## PLANNING COMMISSION MEETING STAFF REPORT

**DATE OF MEETING:** June 20, 2018

**NAME OF PROJECT:** LaBarge Subdivision

**AGENDA ITEM:** Preliminary Approval

**SHEET TITLE**  
 SITE PLAN

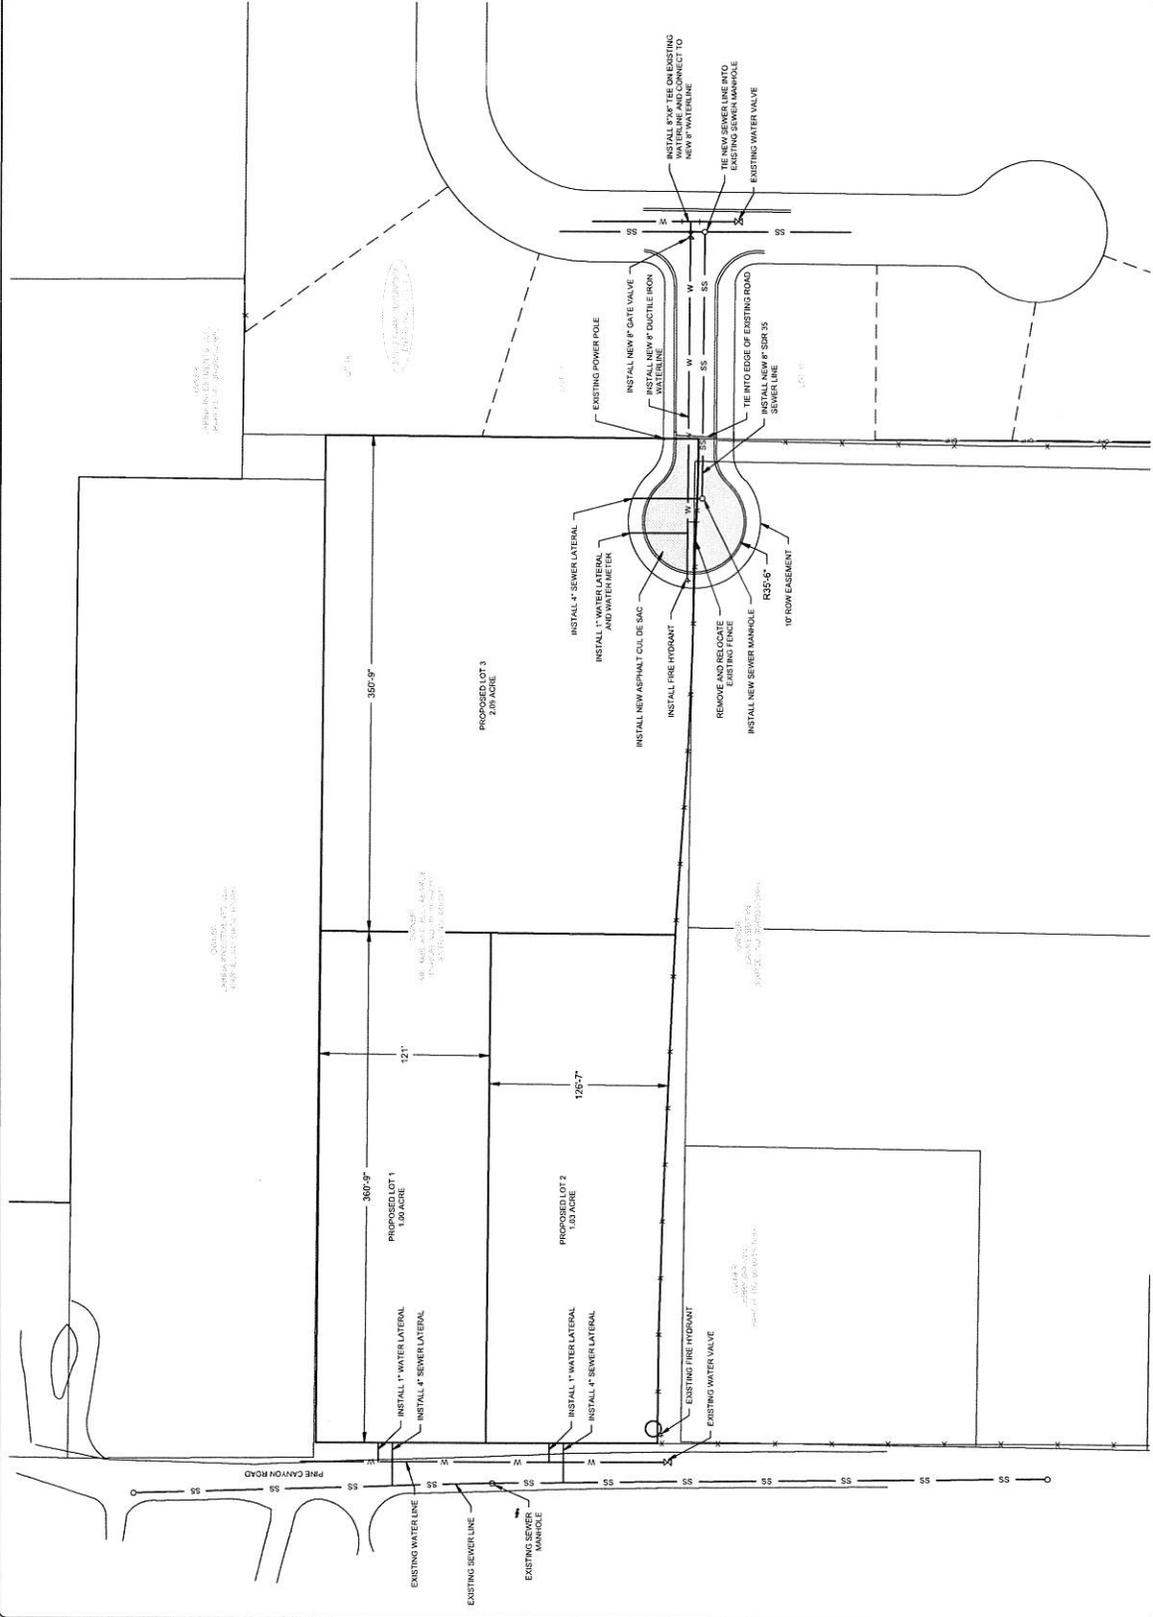
*Access* – Access for two lots is from Pine Canyon Road which is a collector road. Since Pine Canyon Road is a collector road and traffic will only increase over time on this road, the City should consider requiring a turnaround or hammerhead for the driveways of both proposed lots. Also, since Pine Canyon Road is a collector road the City Council must specifically approve direct driveway access to the road if no other options are available.

*Swiss Farm Way cul-de-sac* – The developer will construct a cul-de-sac on the stub road of Swiss Farm Way on the west side of Swiss Farm Subdivision. The cul-de-sac may be temporary if parcel OMI-0230-0-027-034 is developed and the cul-de-sac becomes part of a through road to Pine Canyon Road. A note should be included on the plat that explains this possibility of the road connection from Swiss Farm Subdivision to Pine Canyon Road. In order to be the cul-de-sac, the developer must obtain property from Larry Brown, property owner to the south. This property must be deeded to the City before the recording of the subdivision. Staff recommends an agreement between the developer and Mr. Brown is in place before preliminary approval is granted.

*Pine Canyon Road large-scale subdivision setback* – The required setback on Pine Canyon Road for a small-scale subdivision is 100’ for all structures. The plat will note the 100’ setback requirement.

*Pine Canyon Road Bike Lane* – The master trail plan shows an attached 8’ attached asphalt bike trail along Pine Canyon Road. Staff is proposing that the funds to build the bike lane are added to the general trails fund and that the bike lane is completed in the future as part of a larger improvement project to complete the bike lane along the entirety of Pine Canyon Road.

*Midway Irrigation Company Easement* – Midway Irrigation Company has an easement and a buried irrigation pipe that runs along the southern boundary of the property. This easement must be noted on the plat to protect the pipeline from encroachments and to grant access for maintenance.

1. An agreement between the developer and Larry Brown is made before preliminary approval is granted.

2. Funds to build the bike lane along Pine Canyon Road are added to the general trails fund. Those funds will be used as part of a larger improvement project that will complete the bike lane along the entirety of Pine Canyon Road.
